ST. TAMMANY PARISH

Addendum No.: 1

Bid#: 24-67-2

Project Name: Mandeville Bypass LA 1088 to US 190

SHEET NUMBER	117
ST. TAMMANY	2014EN0001
PARISH PROJECT	NO.15.012
BLK PROJECT	
STATE OF LOUISIANA	
MANDEVILLE BY PASS	
LA 1088 TO US 190	
SEQUENCE OF CONSTRUCTION	
DESIGNED	WCS
CHECKED	DSY
DATE	12/11/2024
BY	11 OF 25
REVISION	
DATE	
DESCRIPTION

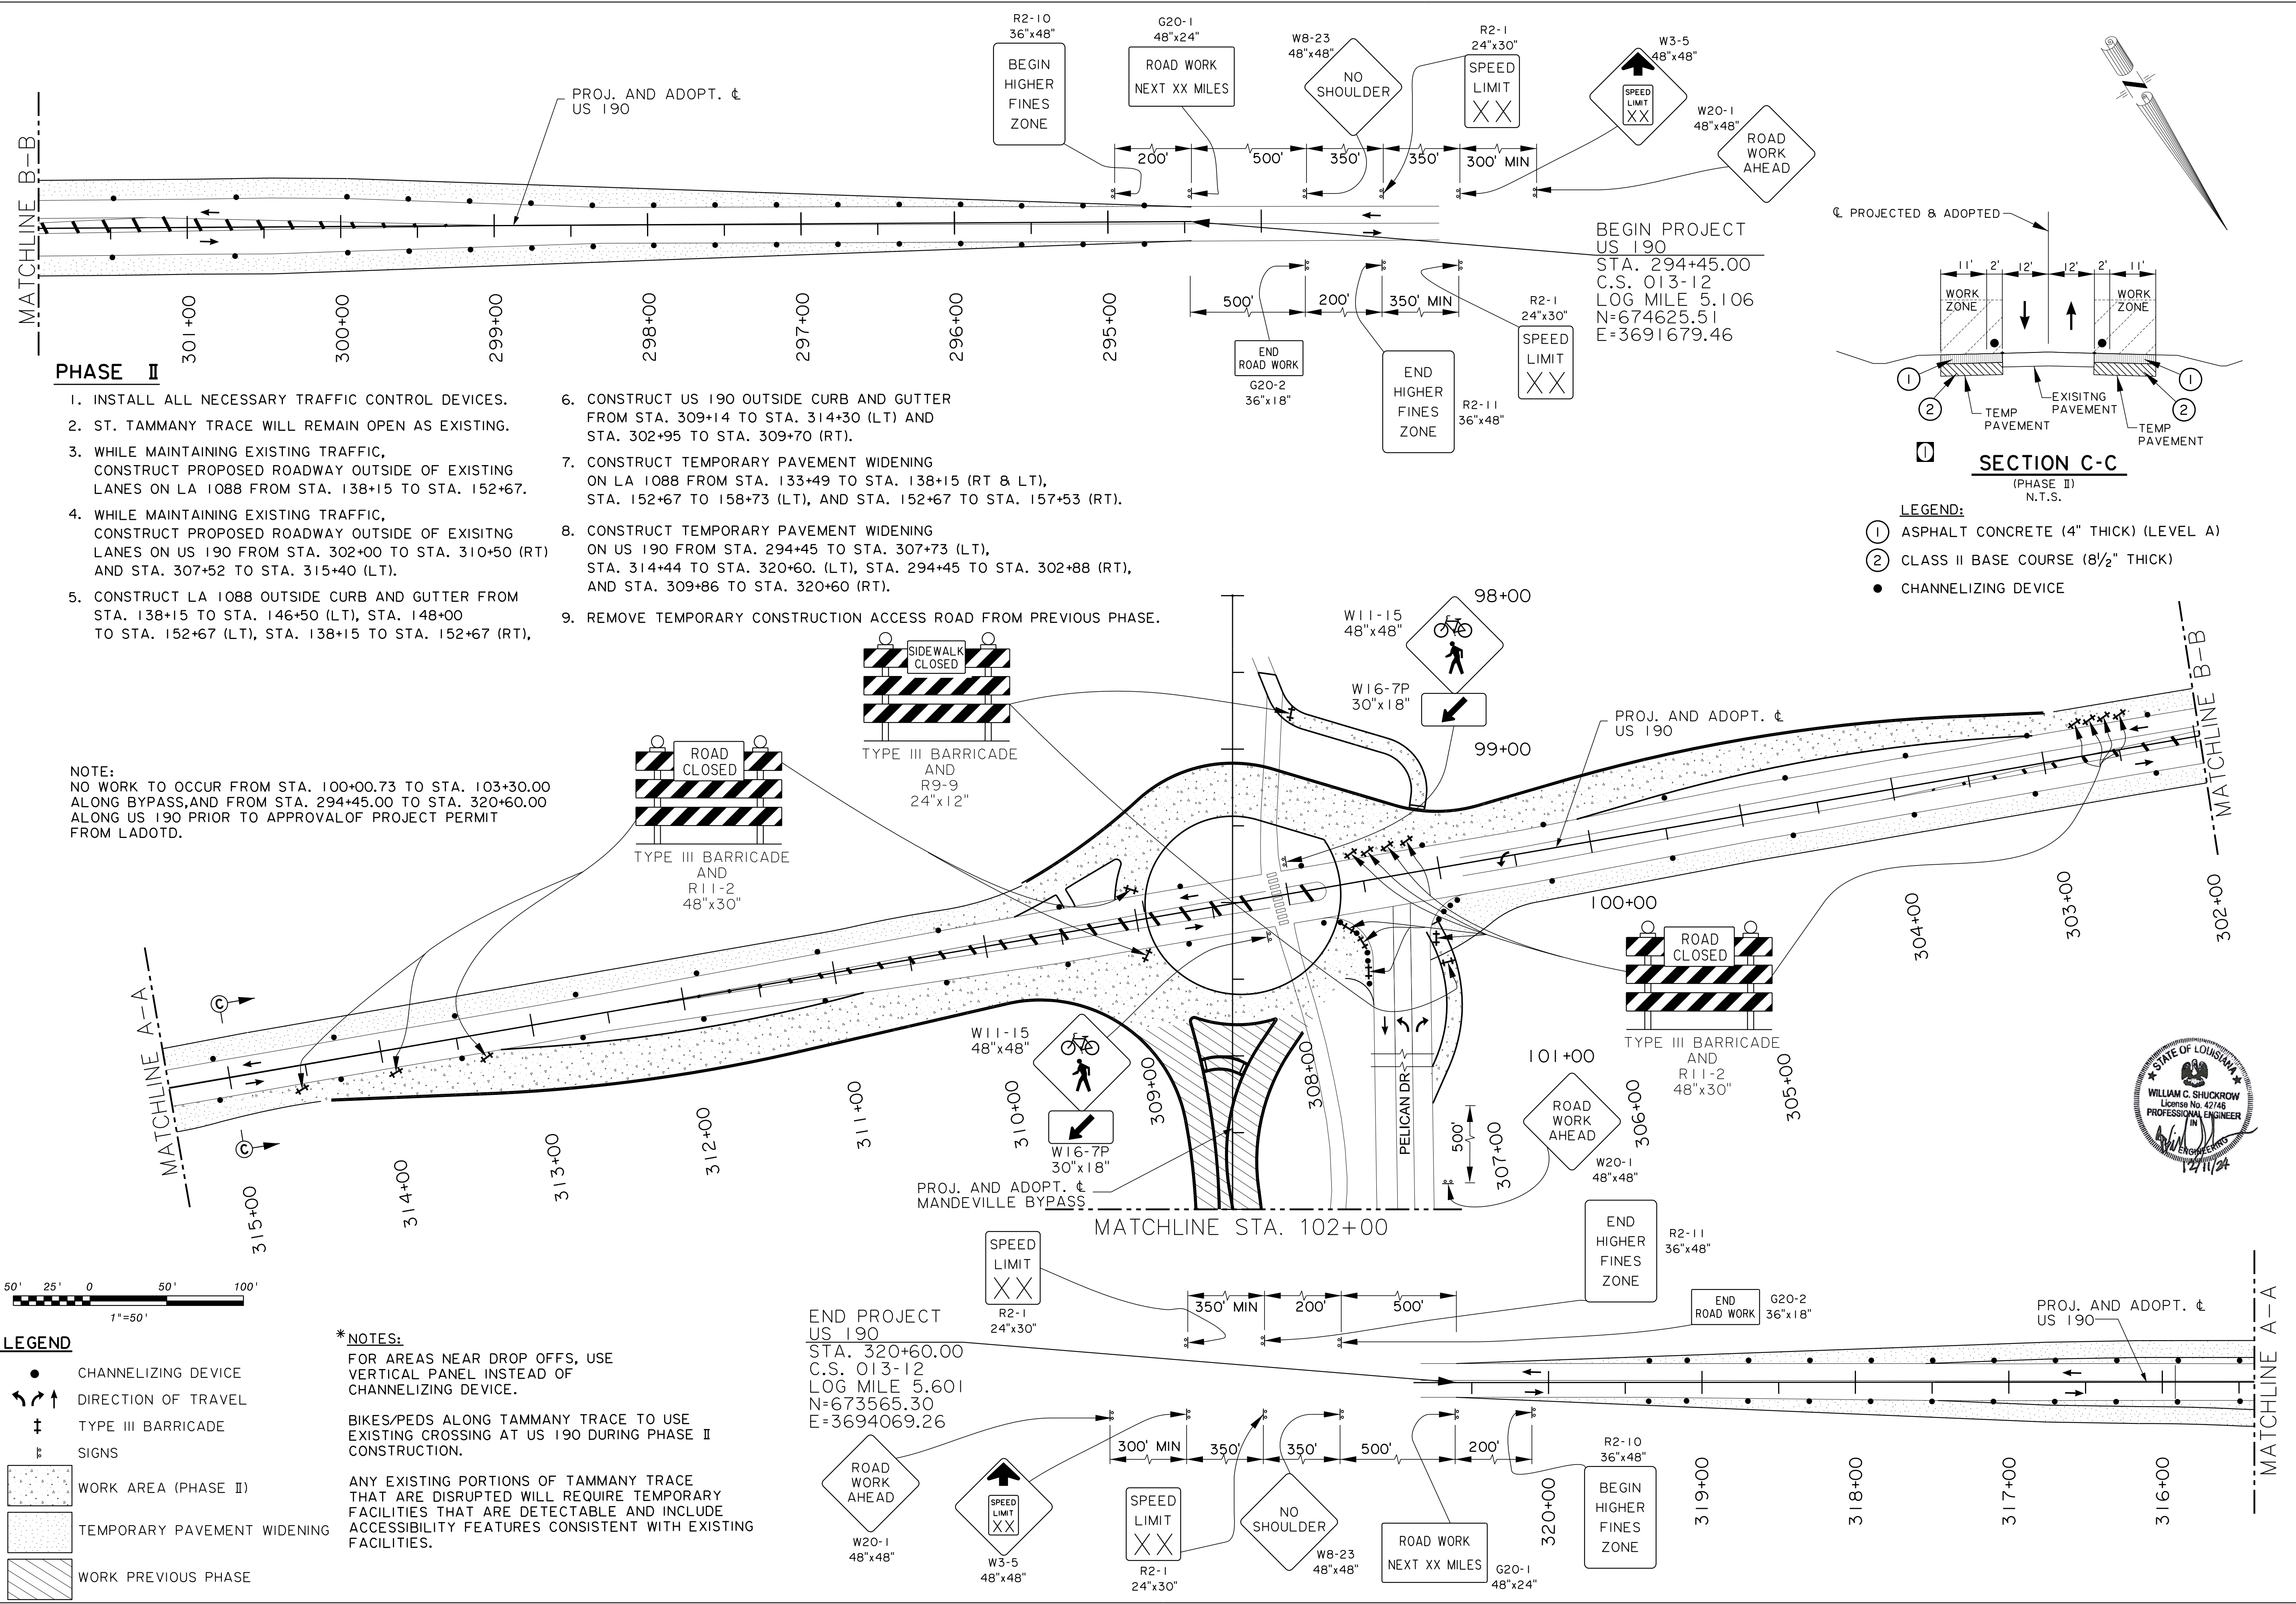
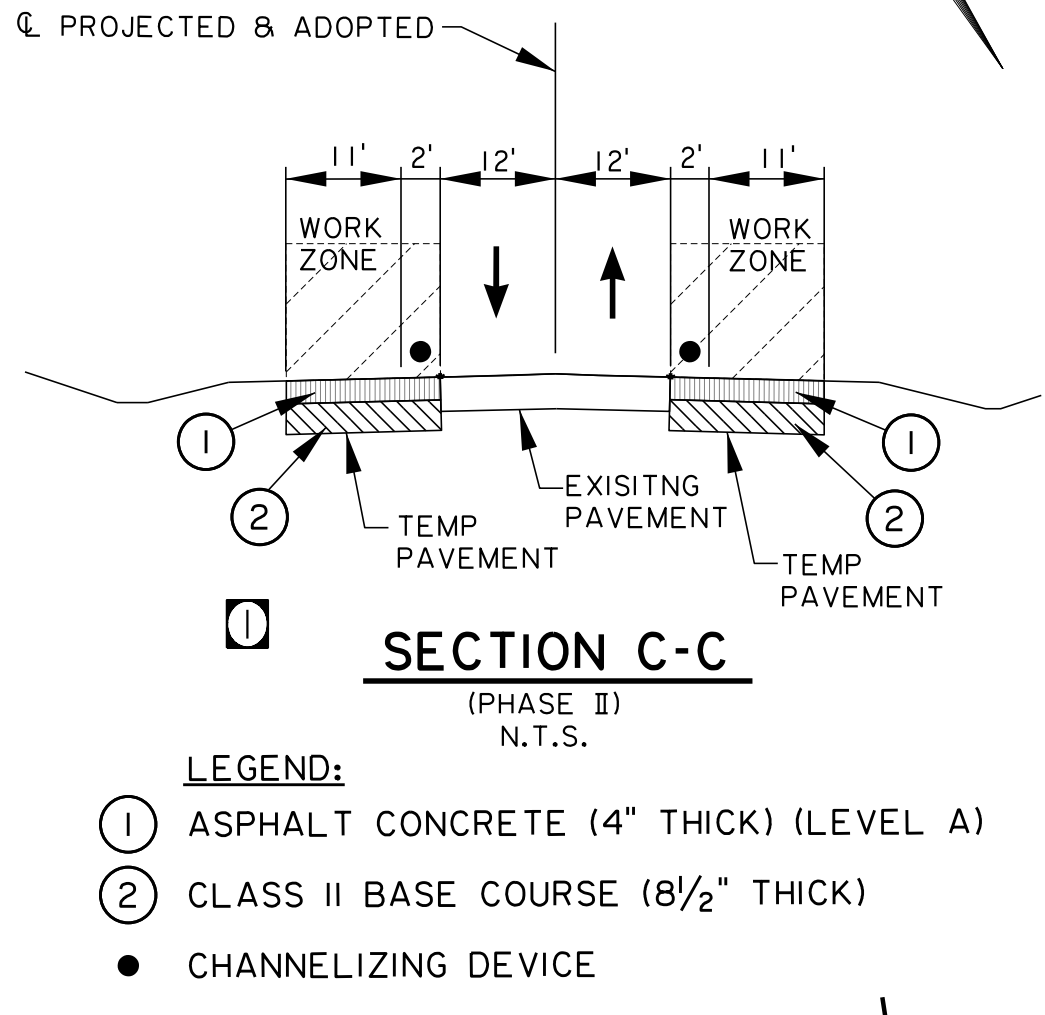
Q10: For item #725-01-00100 – Temporary Detour Roads, I have been unable to locate a specific detail for this work. Can you please provide a detail for the temporary detour road?

A10: See revised sheets 117, 126, 127, and 129 for temporary detour road details. Temporary detour roads will have 4" of asphalt pavement and 8.5" of Class II Base Course.
